MAGICOM MAIN LOGIC SCHEMATIC REVISIONS

WELLS GARDNER NTSC DECODER SCHEMATIC

MAGICOM WIRING HARNESS

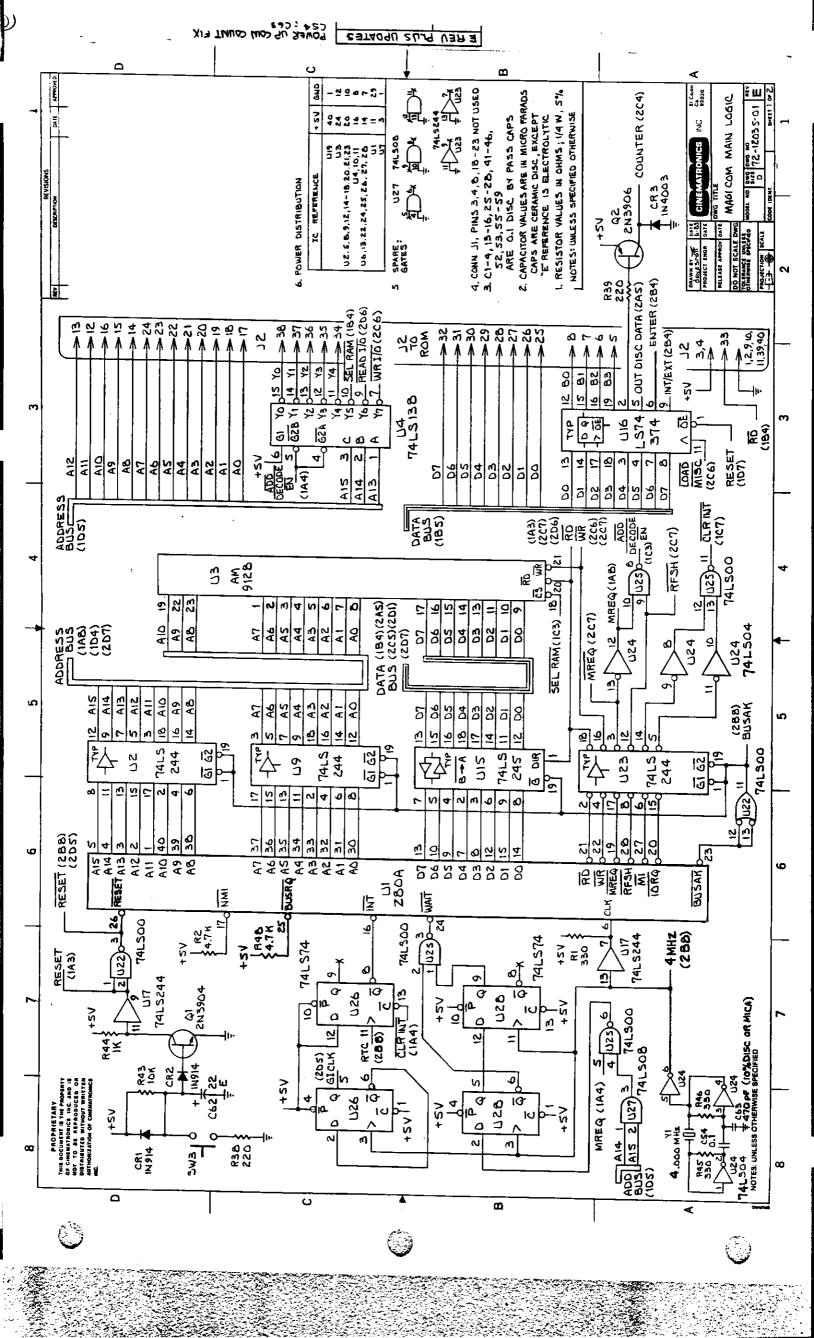
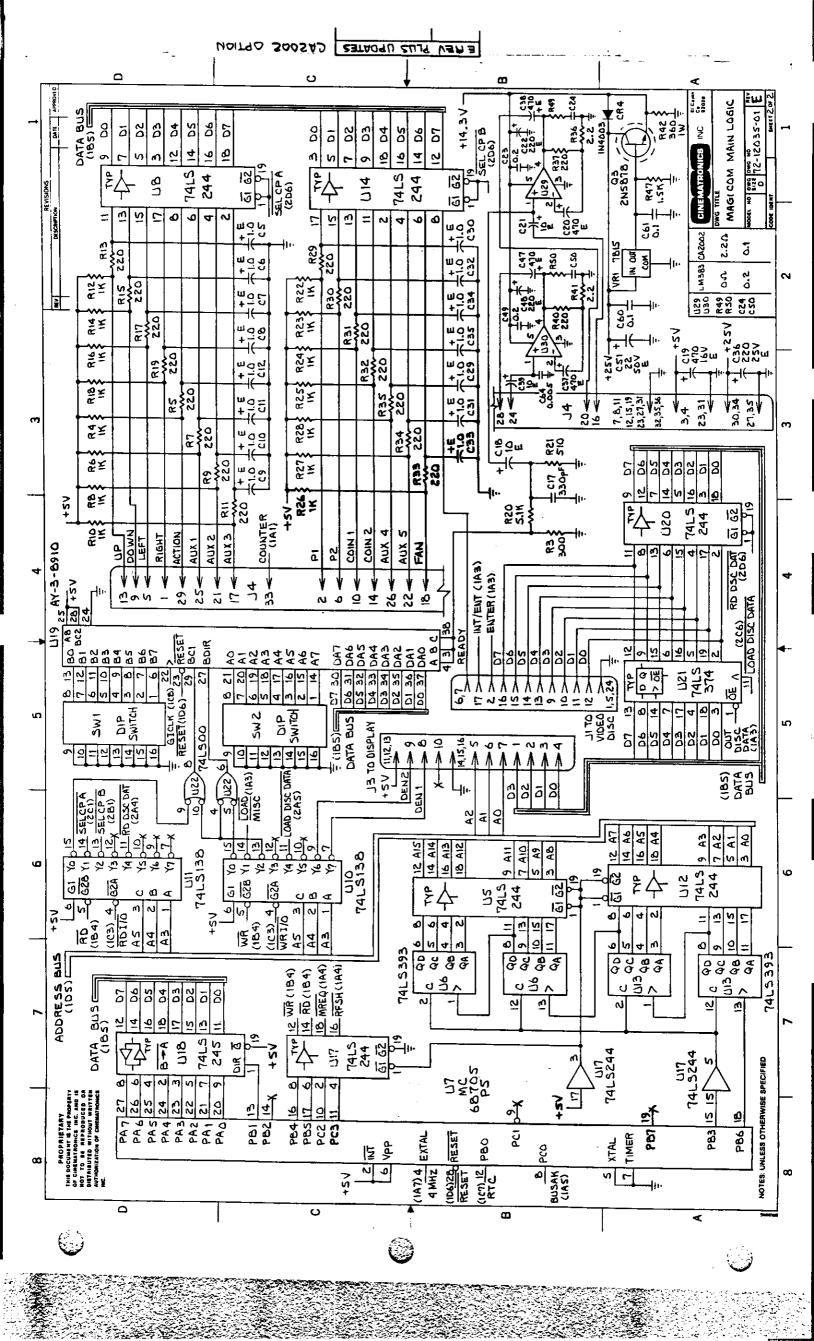
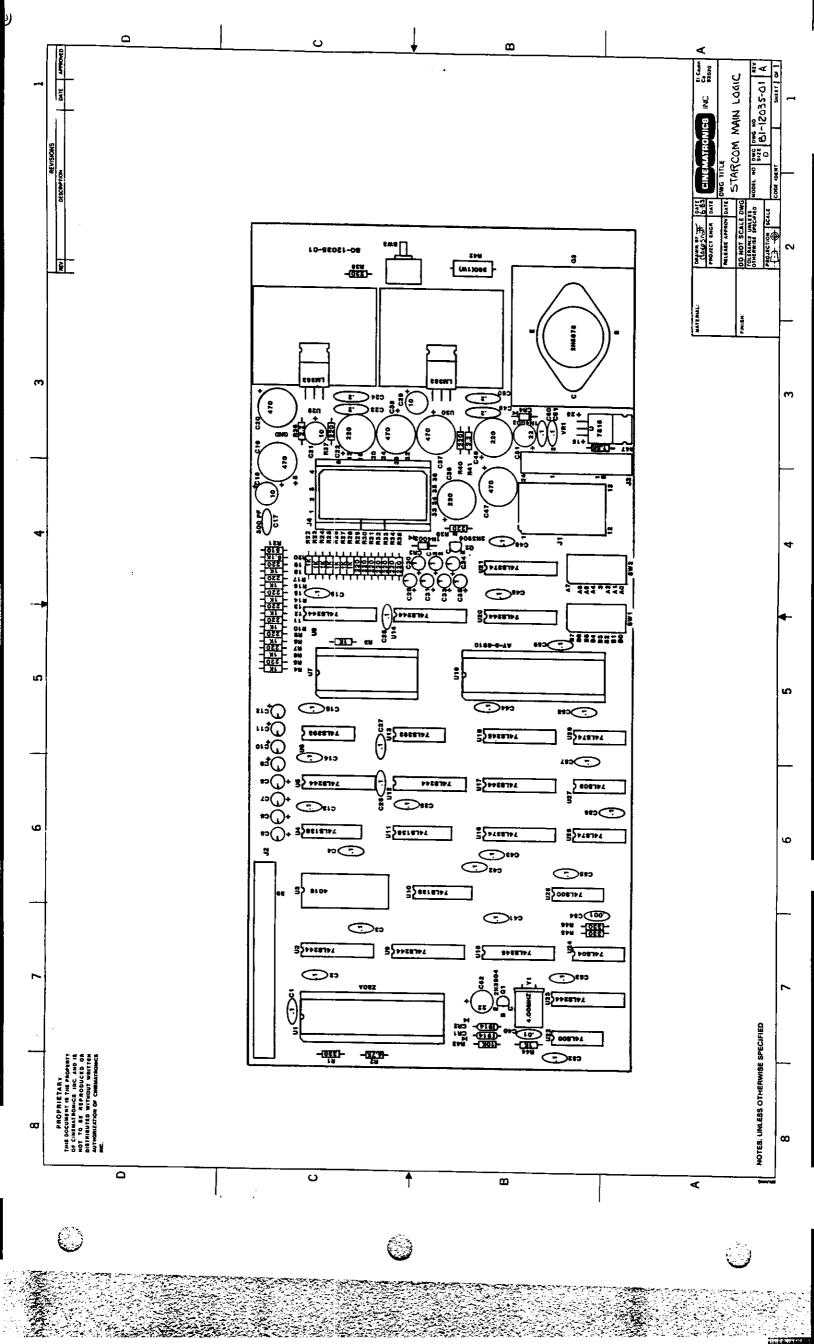
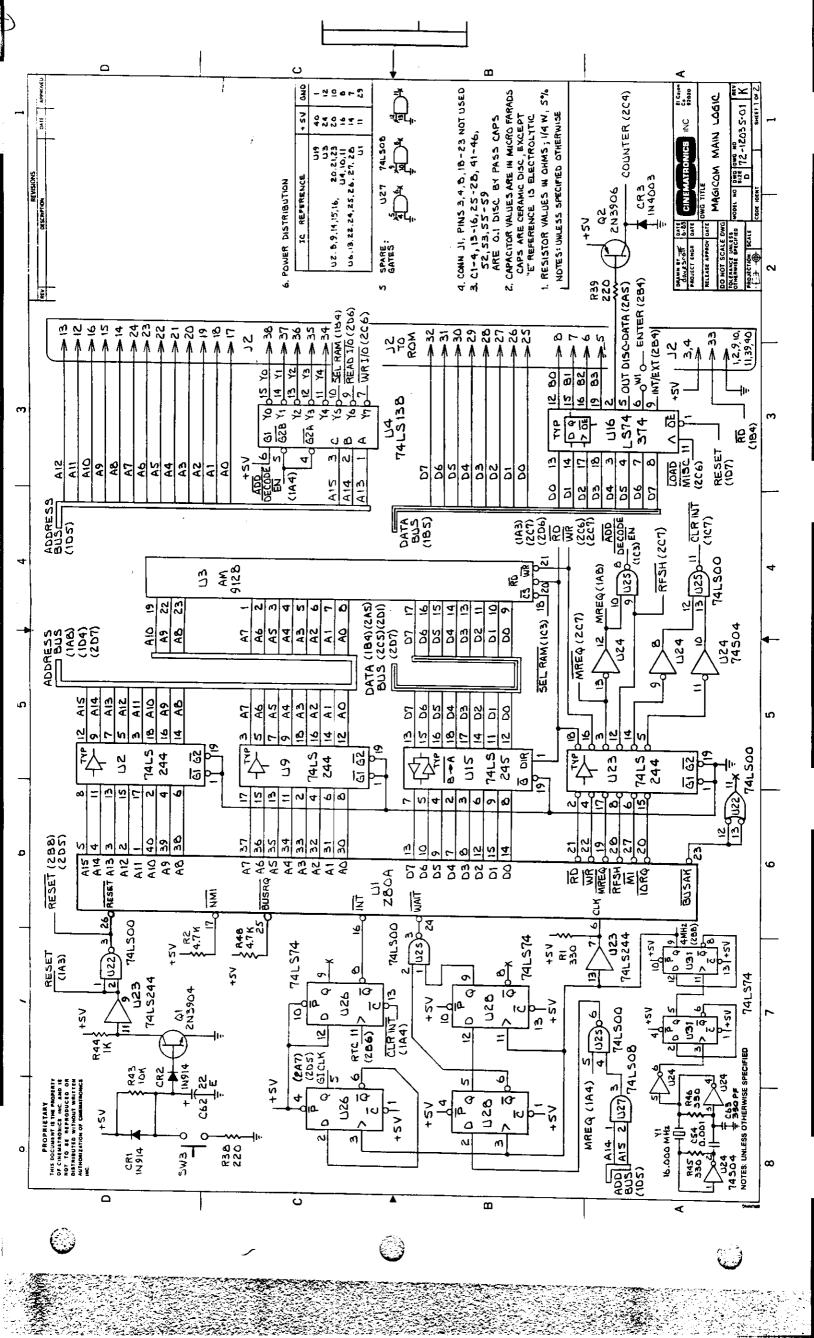
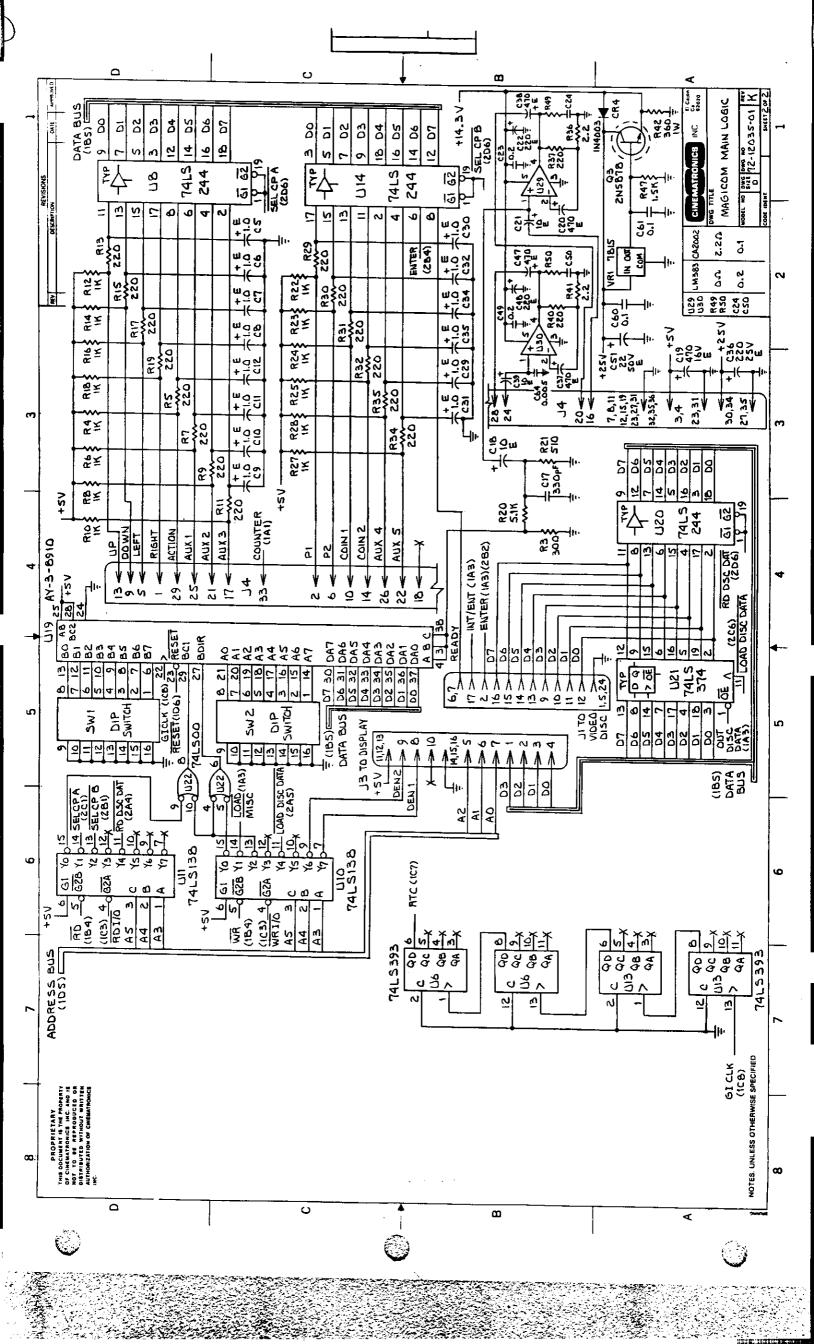
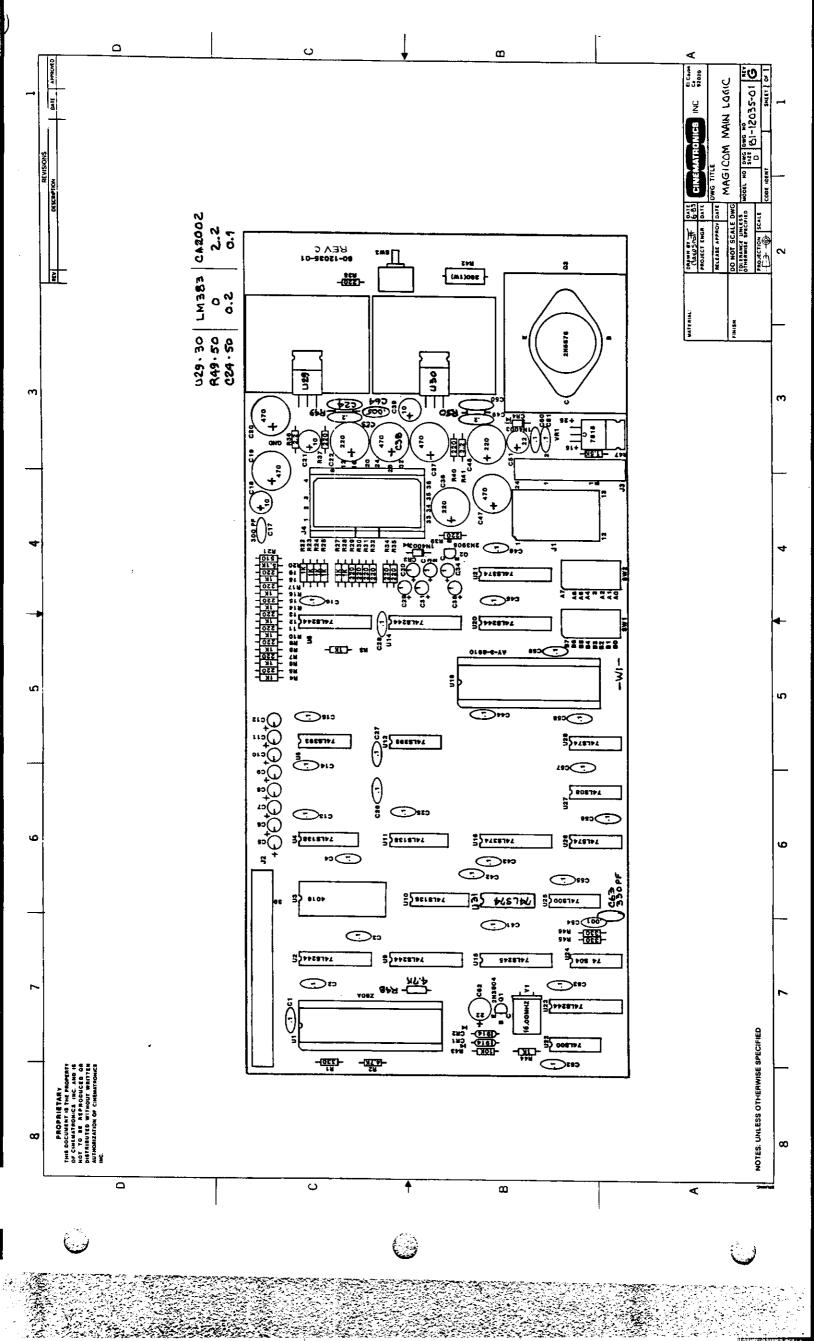
- A. Original release.
- B. R3: Was 1K; became 300.
 D0 on U20 incorrectly shown as Pin 8. Changed to pin 18 on 6/23/83.
- C. Addition of capacitor C63, 220pf disc between U24, Pin 3 and ground. 6/27/83.
- D. C54: Was 0.001uf disc. Became 0.1uf disc on 6/29/83.
 C63: Was 220pf disc. Became 0.001uf disc on 6/29/83.
 74LS244 inserted between 4MHz signal and U1 (280), Pin 6.
 U17, Pins 13 and 7 used these were formerly a spare gate.
 6/29/83.
- E. C40, 0.01 disc tied between U22, Pin 2 and ground is deleted. 74LS244 inserted between Ql collector and U22, Pins 1 and 2. U17, Pins 11 and 9 used these were formerly a spare gate. U1(Z80), Pin 25 cut from U7 (MC68705P5), Pin 9. U1(Z80), Pin 25 tied to R48 (new addition) 4.7K ½W 5% resistor. Other side of R48 tied to +5V.

Ul8(74LS245), Pin 19 cut from U7(68705, Pin 14. Ul8, Pin 19 tied to +5V.

Ul7(74LS244), Pin 17 cut from U7, Pin 19. Ul7, Pin 17 tied to +5V.

U23(74LS244), Pin 1 cut from U22(74LS00), Pin 11. U23, Pin 1 tied to ground.

- F. Deletion of the following effective 7/8/83:
 - U5 74LS244
 - U6 74LS393
 - U12 74LS244
 - U13 74LS393
 - U17 74LS244
 - U18 74LS245

Subtitute U23 for U17 (74LS244) for clock signal into Z80 (U1, Pin 6 from U23, Pin 7) and reset signal into U22, Pins 1 and 2 from U23, Pin 9 effective 7/8/83.

- G. C63: Was 0.00luf disc. Became 470pf effective 9/5/83.
- H. Reset signal sent from U23, Pin 9 to U16, Pin 1 to cure false coin count on power up.
- I. Reference letter not used.

- J. Correct pin out for inputs on U20(74LS244) effective 9/16/83.
- K. C63: Was 470pf disc; became 330pf disc.

C17: Was 330pf mica; became 330pf disc.

Addition of U31(74LS74) to divide clock.

Y1: Was 4.000MHz; became 16.000MHz.

U24: Was74LS04; became 74S04.

Addition of R29 between U29, Pin 4 and C24. Addition of R50 between U30, Pin 4 and C50.

Addition of Jumper W1, when installed, allows board to be used with Pioneer 7820 disc player with proper software.

Deleted: U7 MC68705

Addition (reinstallation) U6, 74LS393

Ul3, 74LS393

U6, Pins 2 and 12, and Ul3, Pins 2 and 12 all grounds.

U6, Pin 6 tied to U26, Pin 11 (RTC).

Ul3, Pin 13 tied to U26, Pin 5 (GI CLK)
